**Re: Board Order 2010-5 and UCG Request for Further Information**

**UTILITIES CONSUMERS' GROUP  
(UCG)**

**Figure 1: Mean Generation to Serve Loads at Varying Levels**

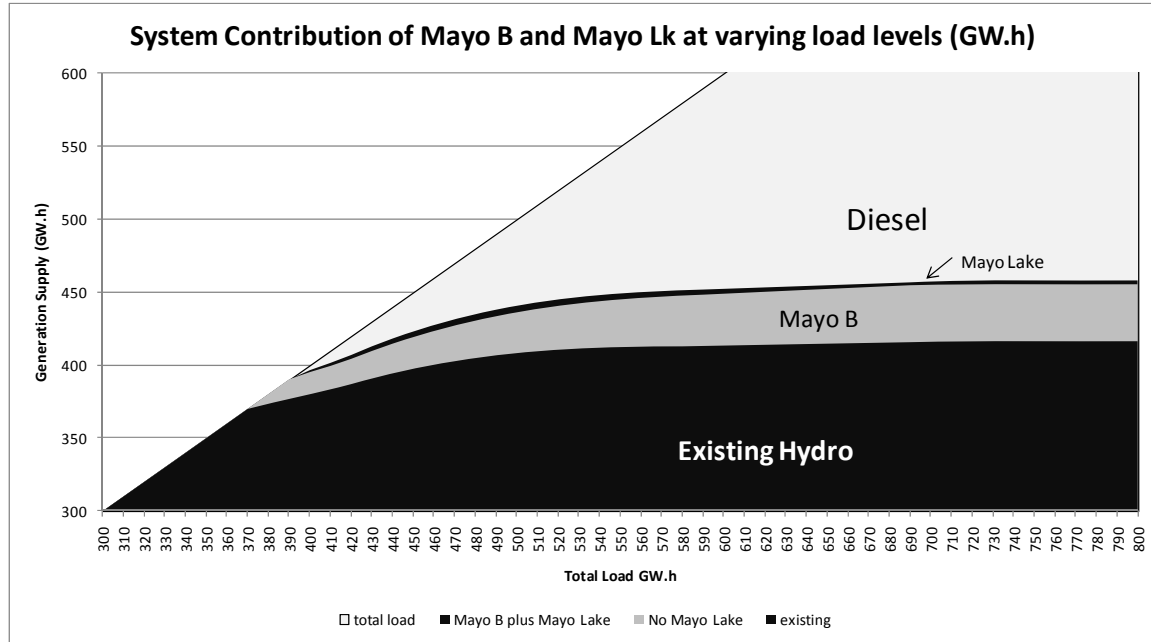
23 a) Please provide the study, assumption and accompanying analysis that led to the  
24 base case forecast, wherein “Mayo B net generation contribution to the system  
25 approximates 26.4 GW.h in 2012, and ranges from 14.9 to 41.4 GW.h/yr over the  
26 Project’s assumed 65 year economic life.”

32 c) Please explain what is meant by the statement, “By comparison, gross  
33 generation at Mayo B during this same period would be expected to fluctuate  
34 considerably less under the same forecast load condition.” Please provide an  
35 example.

30 In order to estimate Mayo B net generation at any specific forecast firm grid load levels,  
31 the analysis in YUB-YEC-1-25(a) uses a method of estimating the mean net generation  
32 contribution of Mayo B corresponding to each particular load level (with different  
33 contribution values depending on whether enhanced storage at Mayo Lake is included in  
34 the analysis). The net effect of this analytical approach, which is explained in more detail  
35 below, is shown in Figure 1 below. The loads in Figure 1 do not arise from any particular  
36 forecast or scenario – they are the comprehensive modeling to show the relationship  
37 between load and generation at each load level:

5 Figure 1 was derived from a detailed hydrologic model that was developed for Yukon  
6 Energy. That model considers the full range of potential inflows based on records for  
7 each location over the period 1987 to 2007 inclusive. The model runs on a weekly time  
8 step and is designed to replicate the dispatch of YEC's hydroelectric stations that would  
9 be used in the operation of the integrated system given the specific loads forecast to  
10 arise in each week including, for example, the following key modeling aspects:

11 Figure 1 represents the interpolation of mean firm generation results for firm load levels  
12 between these modeled values, and largely linear extrapolation for values outside this  
13 range. To ensure very high load levels are not excessively extrapolated, the maximum  
14 generation from the hydro system is capped at the firm plus secondary hydro generation  
15 arising in the highest modeled (575 GW.h) load case.<sup>3</sup>
